Joseph M. Farley Nuclear Plant – Units 1 and 2
Request for Additional Information (RAI) Response on Inservice Testing (IST)
Proposed Alternative RR-P-3, Version 2

RAI Response on IST Proposed Alternative RR-P-3, Version 2

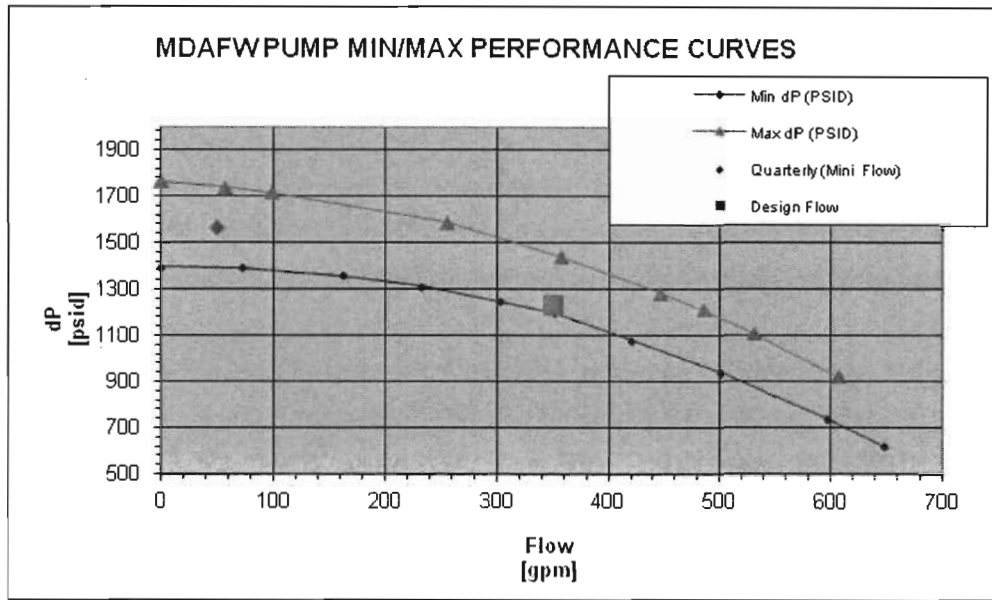
RAI #2: Pump Curves

Provide a pump curve(s) for the four MDAFW pumps. The pump curve(s) should be applicable to the pumps in their current conditions. Indicate on the curve(s) the points for the design flow rate and the expected flow rate through the 2-inch minimum flow line. Explain how degradation will be detected from the Group A tests when the MDAFW pumps are operating at the expected flow rate through the 2-inch minimum flow line.

FNP is unable to produce the specific pump curve for each MDAFW pump; however, shown below are the maximum and minimum design flow rate pump curves for the MDAFW pumps at FNP. The area between the two curves defines the acceptable operating range for the pumps. The two points shown within the area between the two curves, labeled "Quarterly (Mini Flow)" and "Design Flow", represent the most recent IST flow measurements through the 2-inch mini flow line and the design flow rate, respectively. Degradation of the MDAFW pumps will be detected by measuring the flow through the mini flow line (ultrasonic meter) and the pump differential pressure. These values will be compared to the MDAFW mini flow reference value and pump curves as required by ISTB-5121(c) of ASME OM Code 2001.
